Petroglyph Golf Club Conceptual Drainage Plan Re:

Based upon the information provided in your submittal dated 5-17-00, the above referenced Conceptual Drainage Plan is approved for Site Development Plan for Subdivision.

Petroglyph Golf Club Conceptual Drainage Plan and Drainage Report

The Drainage Report and Conceptual Drainage Plan have been revised to reflect your comments dated April 14, 2000. They are being re-submitted for your review and approval for Site Development for Subdivision.

WEST I-40 DMP DRAINAGE BASIN MAP

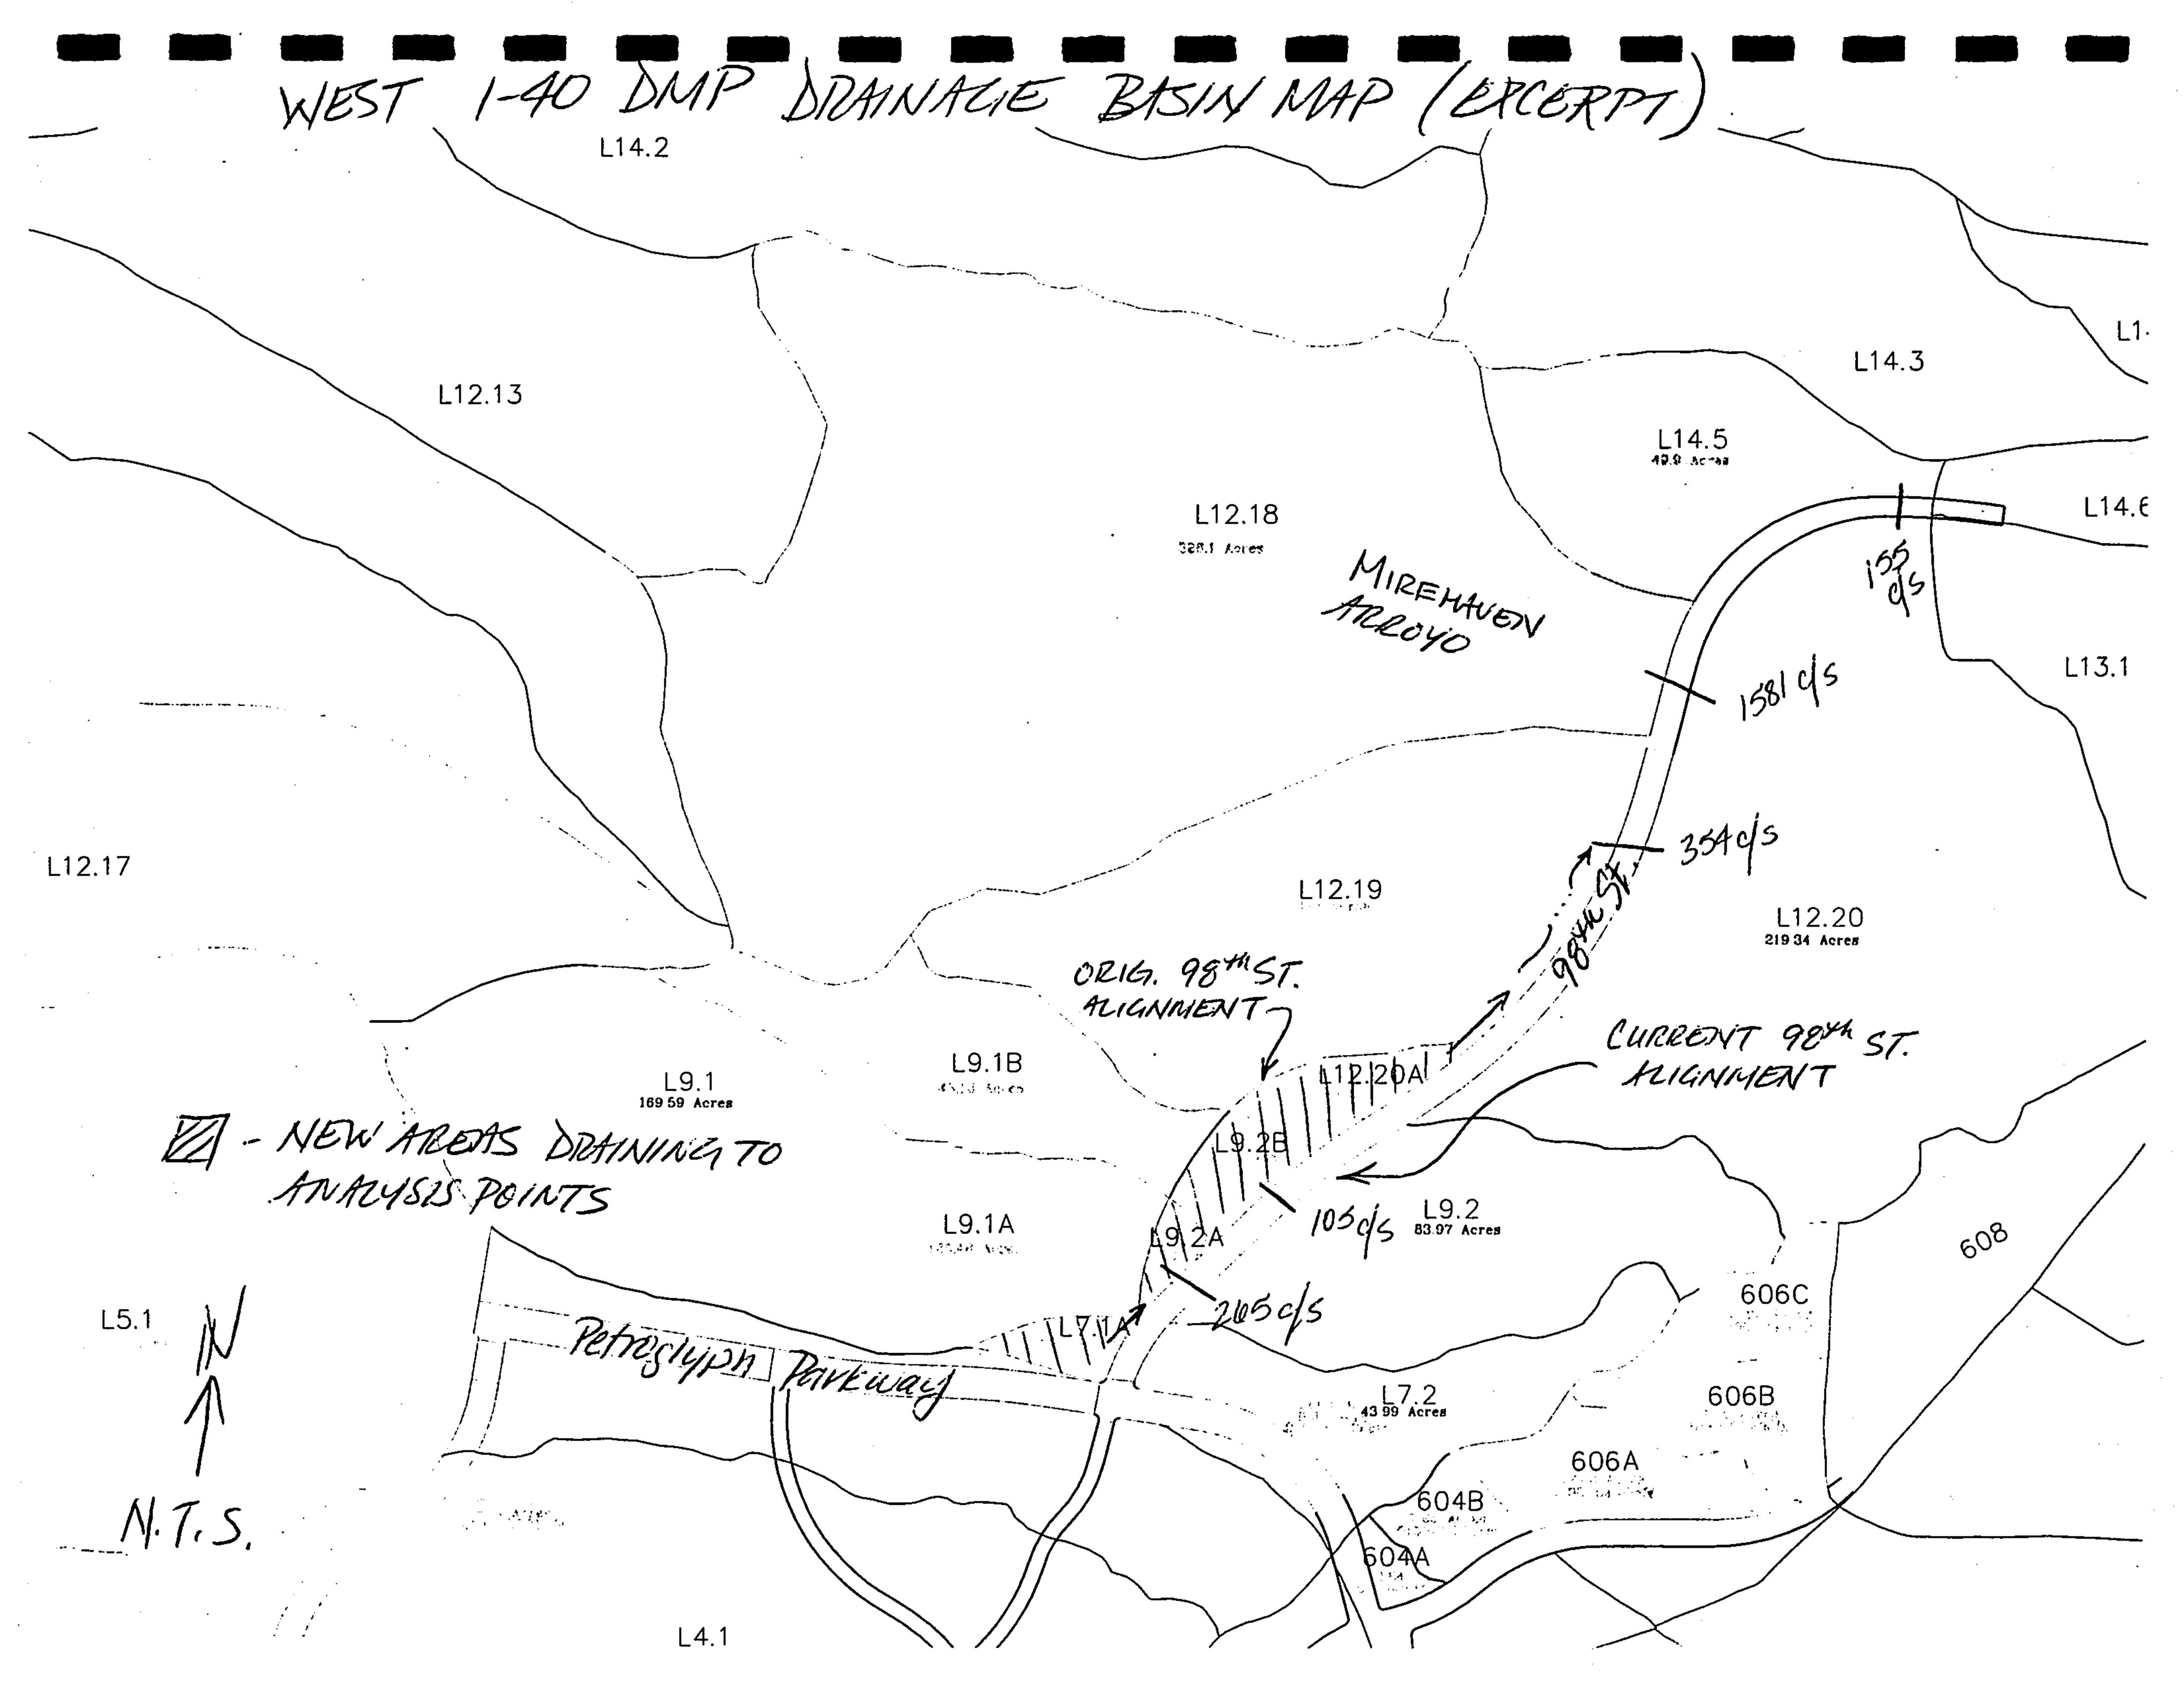
- Has the I-40 DMP report been submitted? This report should be inclusive; i.e. please provide all pertinent information from the West I-40 DMP that will affect this project. On the I-40 basin map, please sketch in your project area.

A figure has been added to the report that shows the project area superimposed on the West I-40 DMP Drainage Basin Map.
